ADDRESS: 264 WATSON

APPLICATION NO: HDC2025-00592

HISTORIC DISTRICT: BRUSH PARK

SCOPE: ERECT PORCH AT FRONT AND SIDE AND REPLACE WOOD WINDOWS

264 Watson, designation slide dating from 1980. Note that the side porch displays decorative detailing (outlined in red) which is consistent with the detailing at the front façade's bay (outlined in yellow)

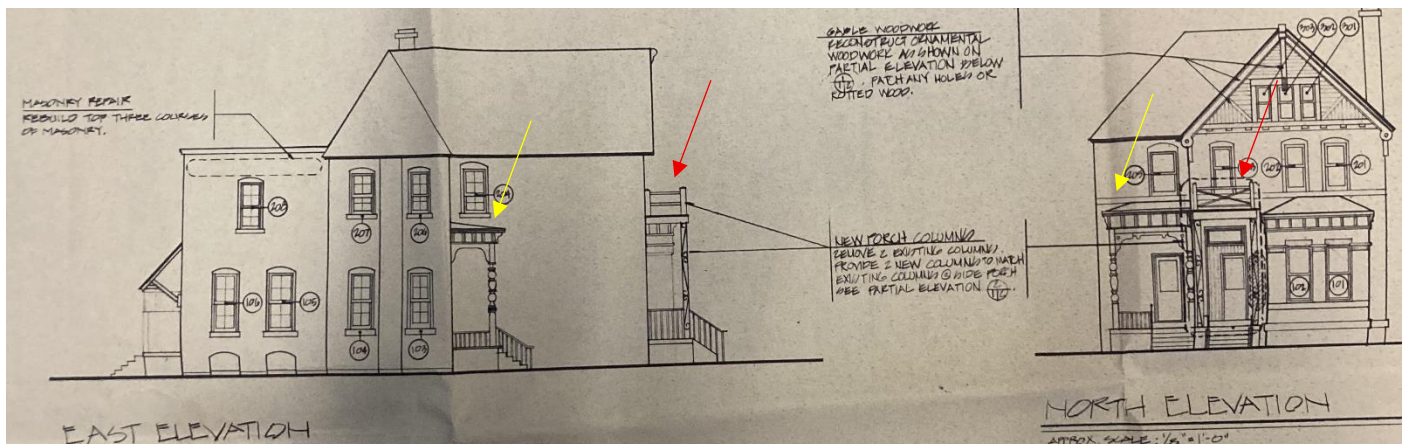
- See the below photo of the house, taken in 1980 at the time of the district's local designation to note the following:
 - The east side porch was present and appears to be of historic age/original to the date of the house's construction. Note that the side porch displays decorative detailing

(outlined in red) which is consistent with the detailing at the front façade's bay (outlined in yellow)

- The front porch is not of historic age

Rehab drawings from 1981, showing the proposed design of the new porch, which takes cues from the historic east side porch.

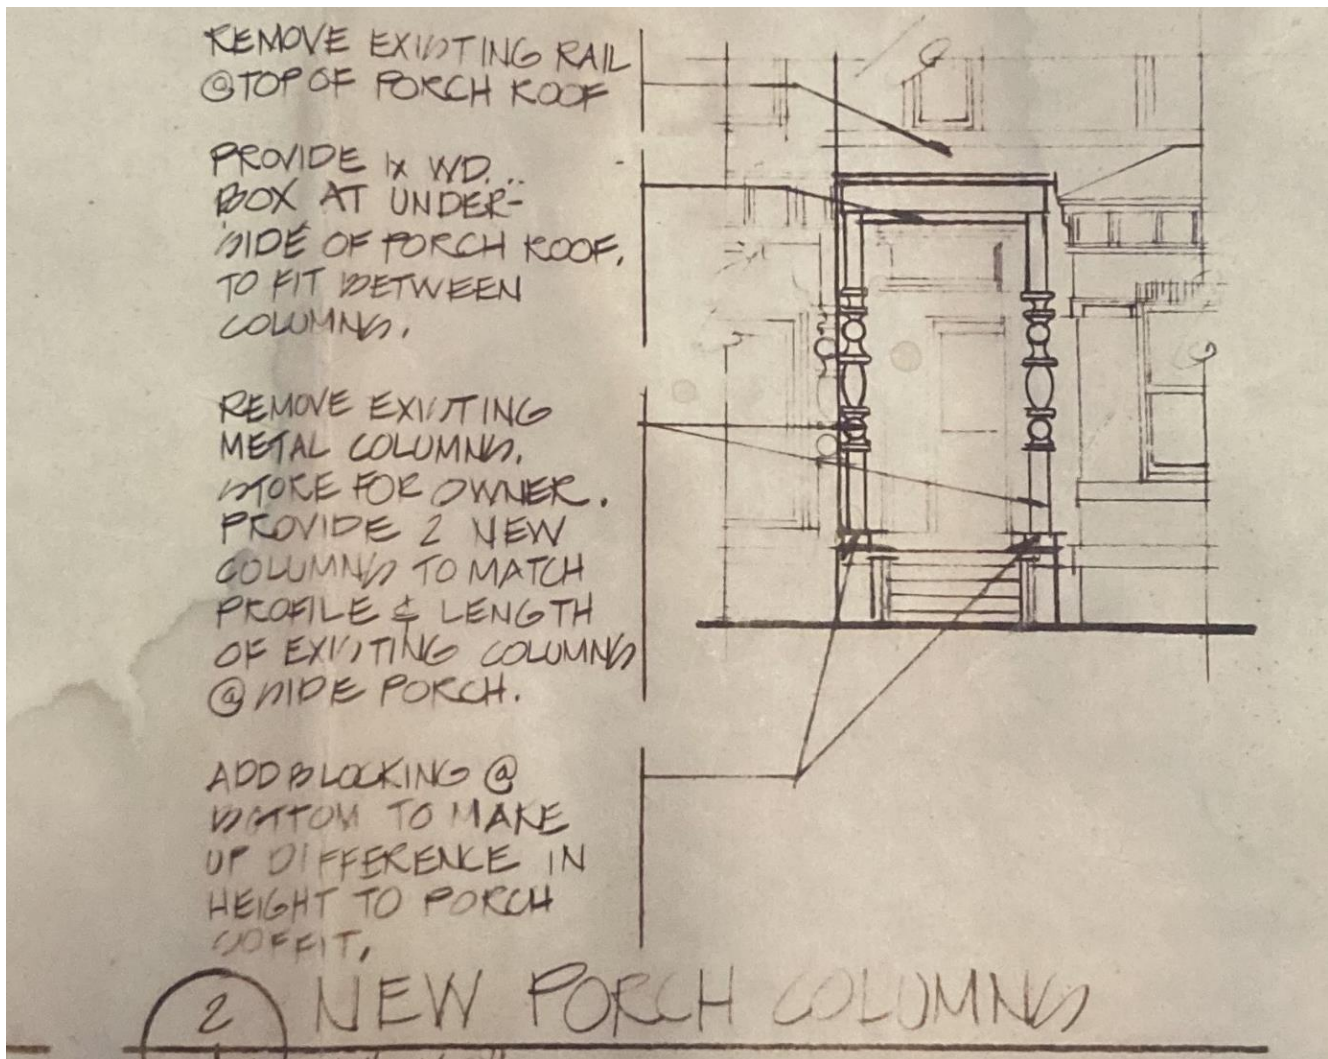
- The above Sanborn Maps indicate that the building had a distinct east side and a front porch as early as 1887. This condition continues to the current day.
- With respect to the current front porch, a review of HDC records revealed that the house was rehabilitated in 1981 under a City-funded, home repair program. Exterior work items included the installation of a new asphalt shingle roof, the addition of the current ornamental woodwork/vergeboard at the front facades gable end, the addition of new columns at the front porch to match those present at the historic east side porch, and the removal of the rooftop rail at the front porch (see the below).

Rehab drawings from 1981 showing the front (yellow arrow) and side porch (red arrow) conditions at that time. The project proposes to replace the non-historic front porch with a new porch which takes design cues from the historic east side porch. Note that the side porch was not proposed for repair, likely because it was in good condition and retained elements that were consistent with the building's historic character.

East side porch, current appearance. Note that the east side porch's decorative details match those at the front façade's bay window. Specifically, the brackets at the porch soffit/eave area match those at the front facade bay (outlined in yellow). Provided by applicant

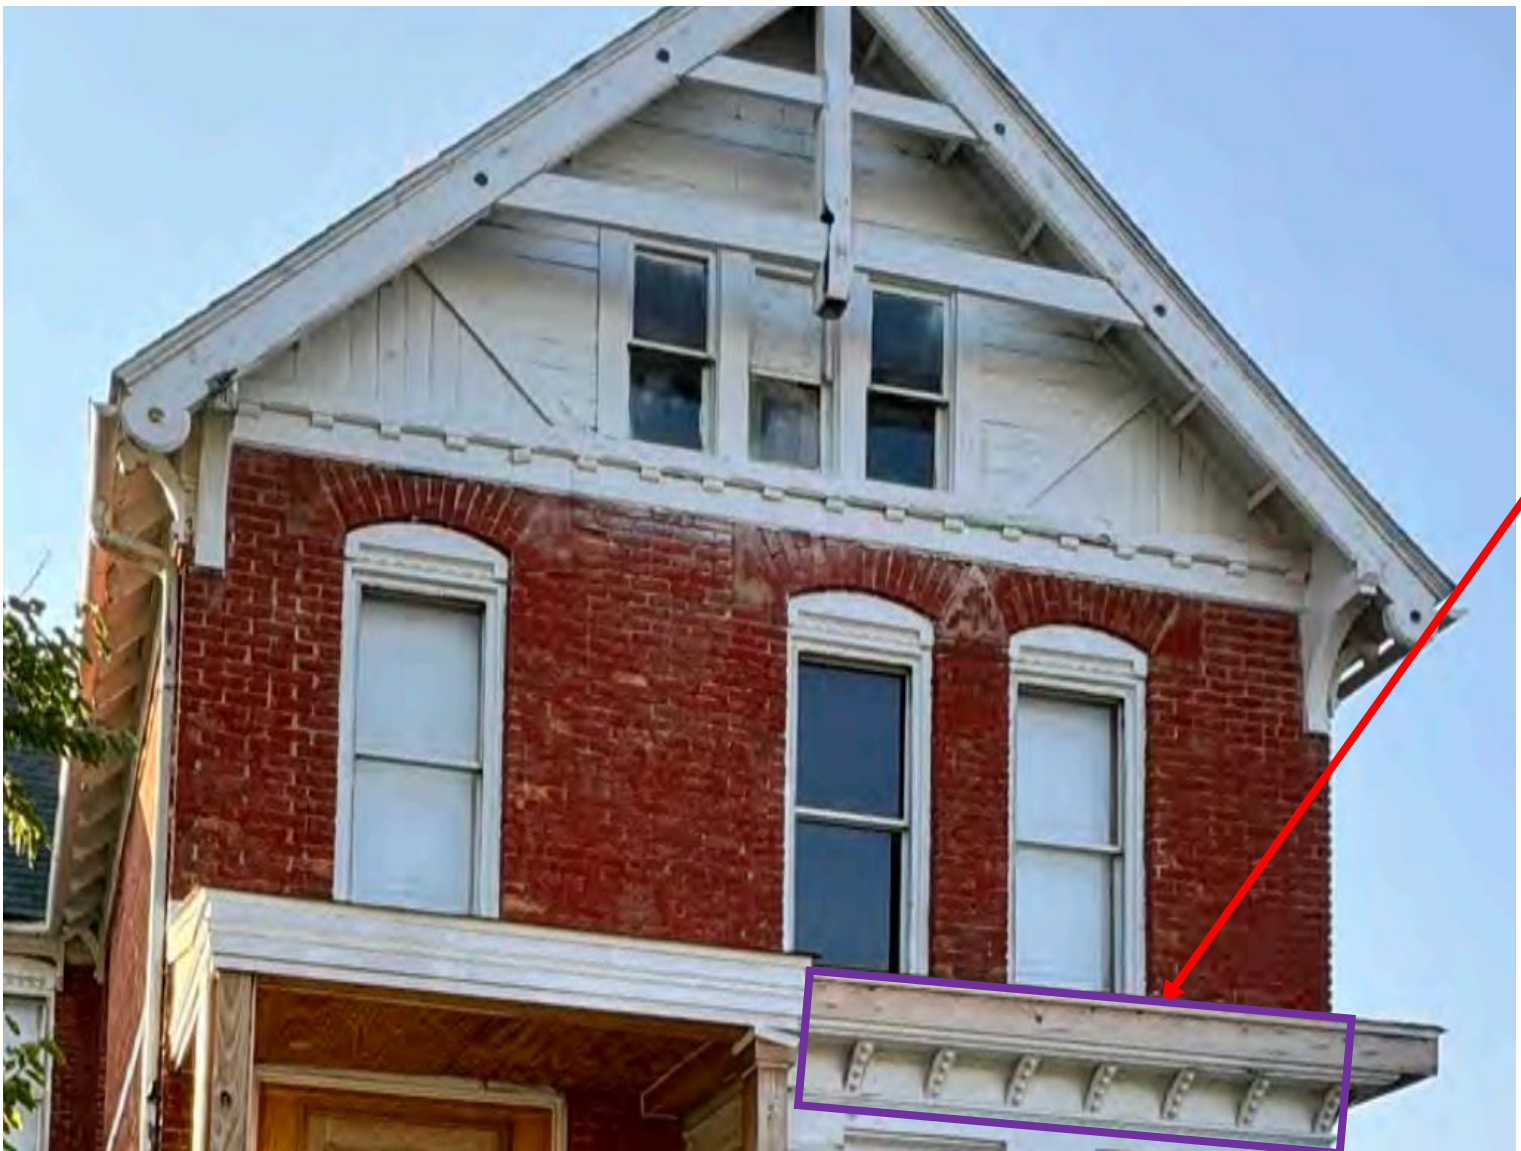
- With respect to the historic east side porch, staff notes that it currently appears much as it did at the time of local designation/when the building was identified as Contributing to the historic district. It is staff's opinion that the side porch is a distinctive character-defining feature of the building as it displays historic-age details which are associated with the Queen Anne style and are reflective of decorative detailing elsewhere on the building. A review of Sanborn maps (provided above) indicates that the porch has been extant since 1887. Also, note that the Commission determined that the east side porch was a distinctive, character-defining feature of the property at their 12/11/2025 regular meeting. The Commission upheld this position at their 02/12/2025 meeting. The porch also appears to remain in relatively good condition and therefore should be kept and, where deteriorated, repaired using in-kind materials. The below indicates the the areas/elements of the porch that are in poor condition and the elements that do not date from the building's original construction as noted by the applicant.

Front façade, current appearance. Note that the east side porch's decorative details match those at the front bay window. Specifically, the brackets at the porch soffit/eave area match those at the front facade bay (outlined in purple). Provided by applicant
